40 CFR 190
ENVIRONMENTAL RADIATION PROTECTION REQUIREMENTS FOR NORMAL OPERATIONS OF ACTIVITIES IN THE URANIUM FUEL CYCLE

FINAL ENVIRONMENTAL STATEMENT

U.S. ENVIRONMENTAL PROTECTION AGENCY
Office of Radiation Programs

IX. RESPONSE TO COMMENTS

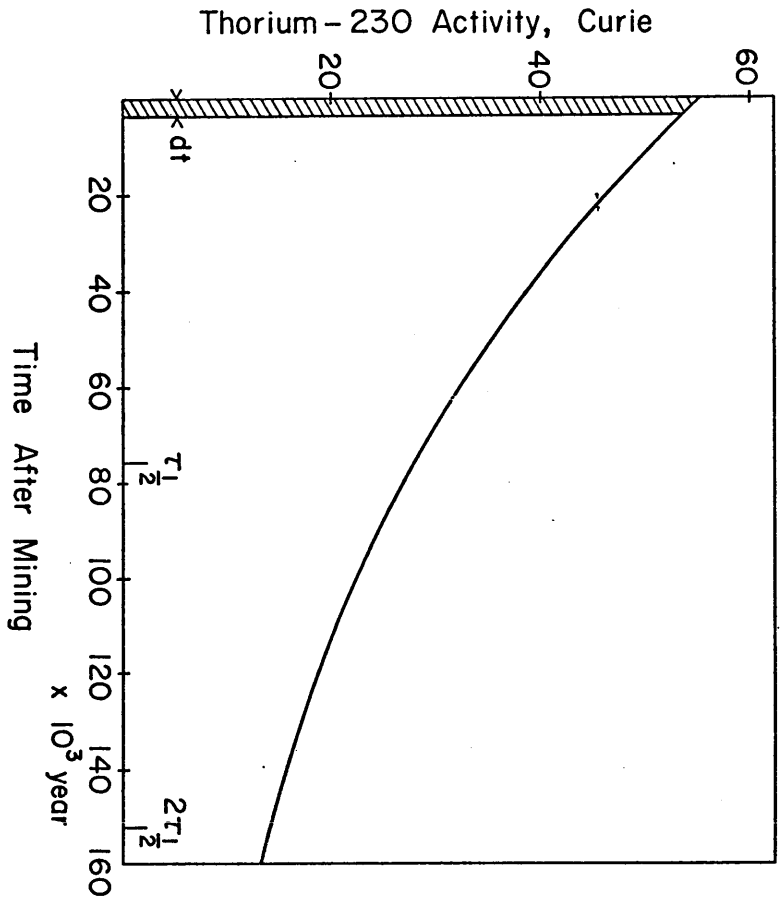
A: The activity of the thorium-230 set free by burning coal follows the exponential time dependence shown in Fig. 1, except that, per GW(e)y, the scale on the vertical axis will be 50 times smaller. The uranium in the ash, however, will cause the thorium activity to remain constant for the order of a billion years, since the decaying thorium-230 is constantly replenished by the uranium-238. Of course, the same problem will be encountered with the uranium-238 presently stored at the nuclear fuel enrichment plant, unless ways are found of either burning it in a breeder, or else disposing of it safely.

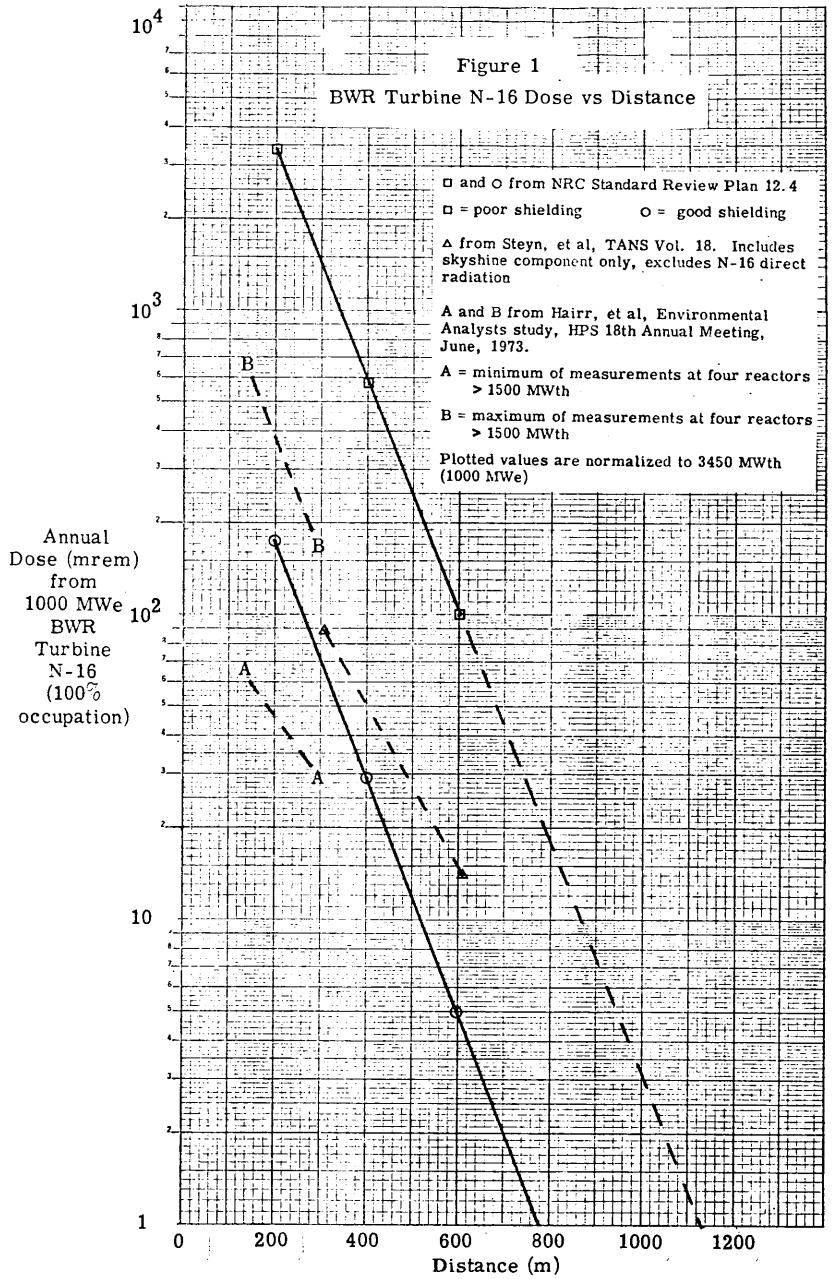
Doses from turbine building N-16 are not yet known very accurately. Results of calculations by Steyn et al[2/] and measurements by Hairr et al[3/] are included in Figure 1 for comparison. The lower bound NRC curve does not appear unrealistic.

It is evident from Figure 1 that the location of the nearest resident is crucial in determining the importance of direct radiation dose. Data on distances to nearest residences are also sparse, but data on distances to site boundaries of 64 sites have been summarized by NRC.[4/] The average site boundary distance is 740 meters, but 10 of 64 sites have site boundary distances less than 500 meters.
